### DATE OF BULLETIN:

7-03-2017

### MODELS AFFECTED:

SPORT	PRO
CARBON	GTX
HERO	XR

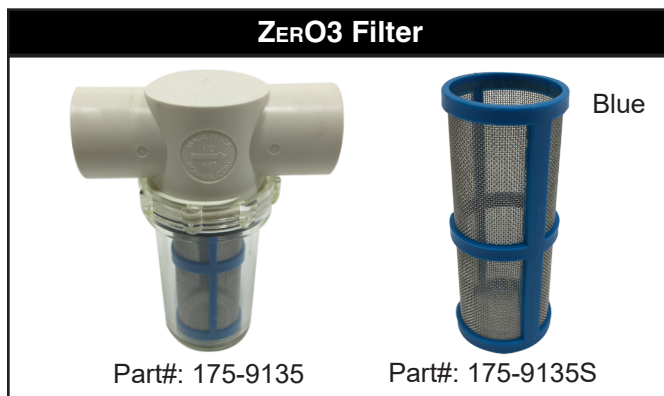
New ZERO3 and Suds combination options available on machines.  
New standard Inline Solution Filters for machines.

Added ZERO3 Aqueous Ozone Onboard system option. ZERO3 plumbing is separate from regular plumbing ZERO3 and Suds to run simultaneously or individually.

New tanks feature Suds reservoir allowing non-proprietary soap dispensing with three dilution settings: OFF, 250:1 (approx. 1/2oz / gallon) or 125:1 (approx. 1oz / gallon) ratios.

Part #:175-9130 - Regular Solution Black (40 Mesh)  
Part #:175-9135 - ZERO3 Optional Blue (50 Mesh)
